SITE AND DEVELOPMENT PLAN AMENDMENT STAFF REPORT GALLERIA

20-08SP

REQUEST: A Site and Development Plan Amendment for development of a commercial/retail building on an outparcel of the Galleria on Venice Avenue along with associated parking, landscaping and other improvements.

GALLERIA PUD

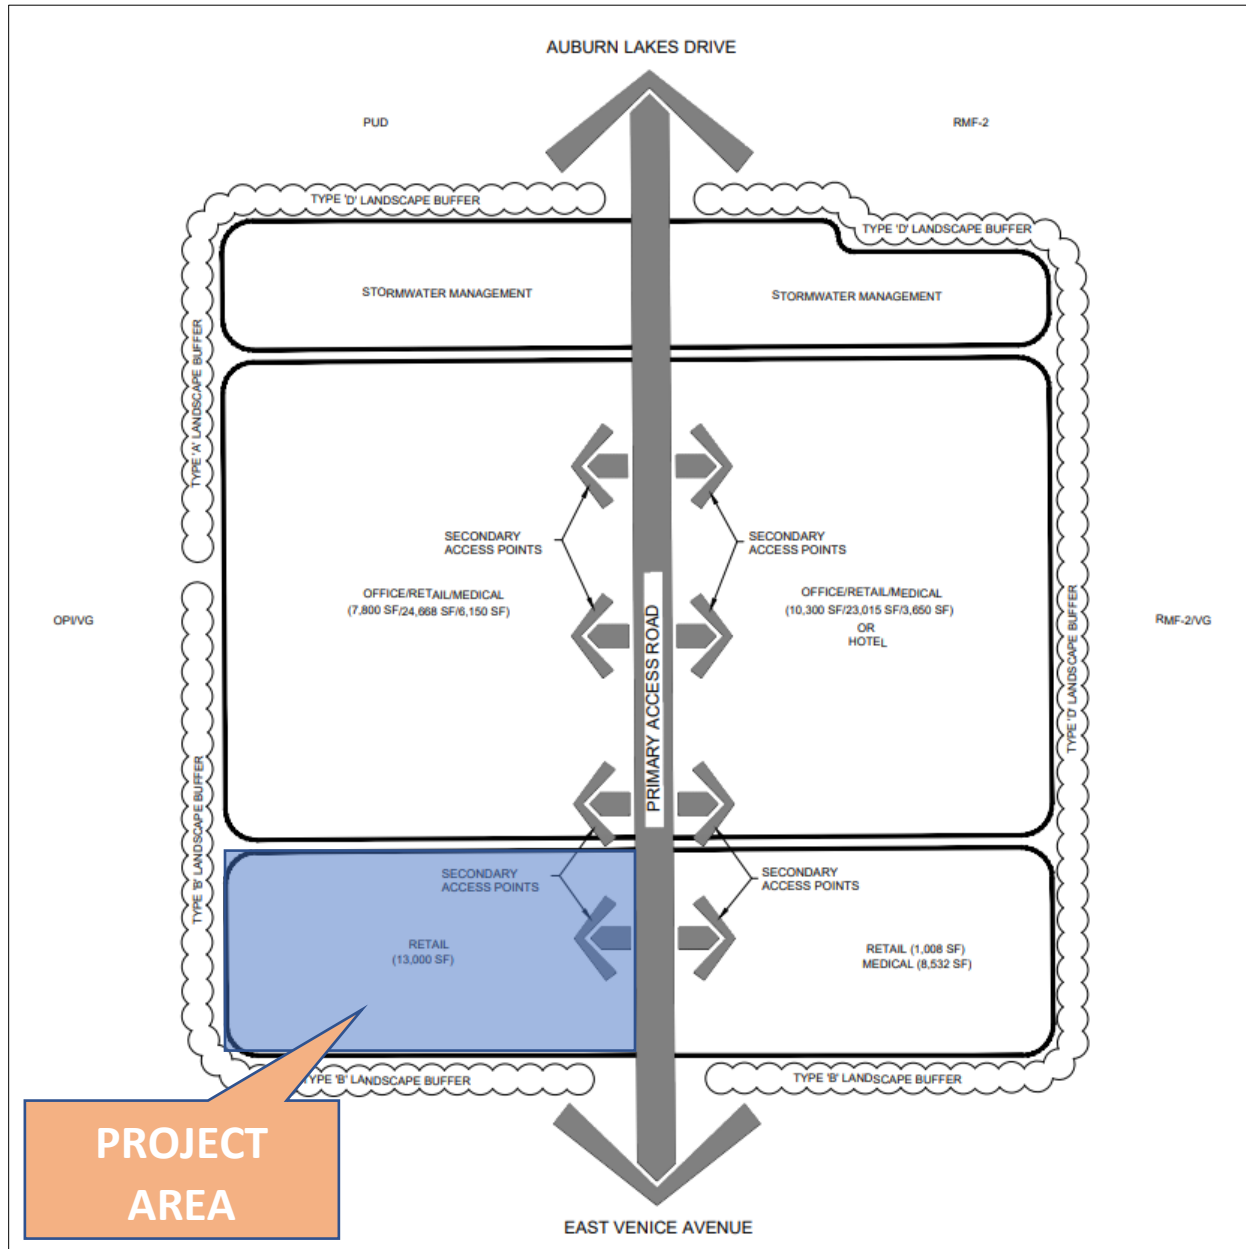
The subject project area is highlighted above on the approved PUD. Location, size and access points are all compliant with the PUD. In addition, landscaping is compliant with both the PUD and the requirements of the VG overlay district.
